Subject: **FCC Class II Permission Change Request for FCC ID: 2ADTD-KB6003**

This is to request a Class II Permission Change Request for FCC ID: **2ADTD-KB6003** ,
originally granted on 2017-04-24 .

power supply circuit change:

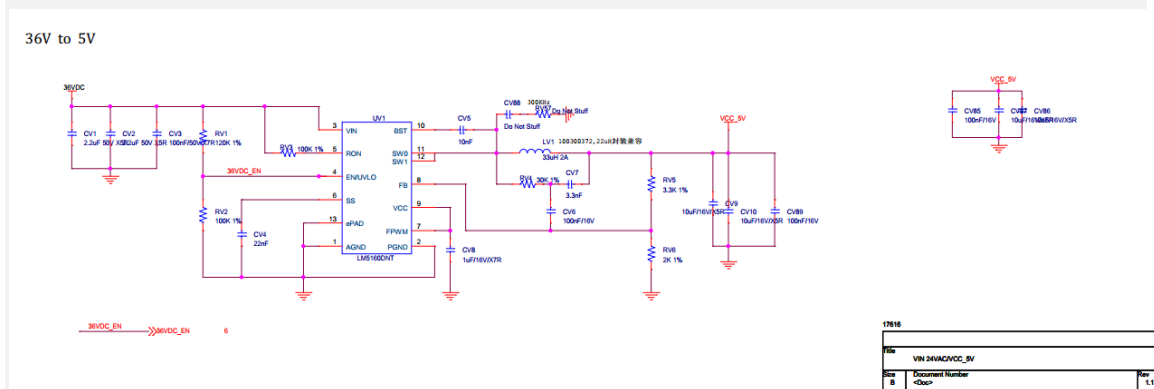
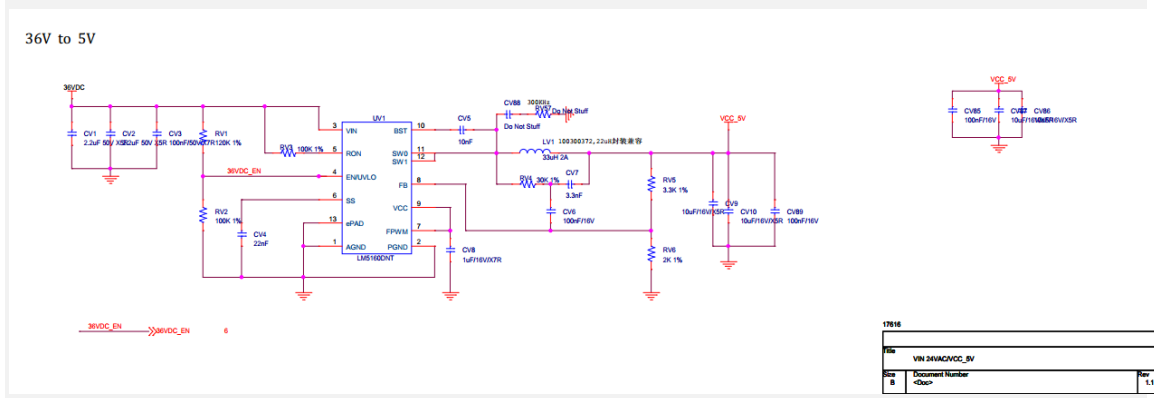
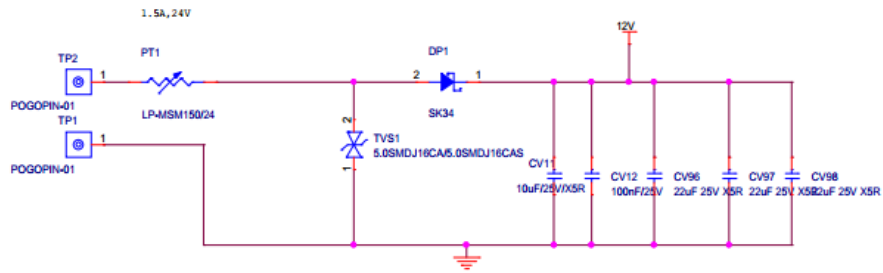
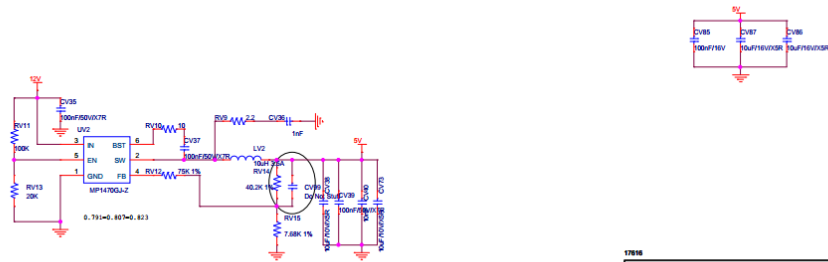
Product specification change:

Before the change: AC 16V-24V, 0.37A MAX, 6W MAX

After the change: AC 16V-24V, 0.37A MAX, 6W MAX or DC 12V, 0.5A MAX

Before the change:

After the change:
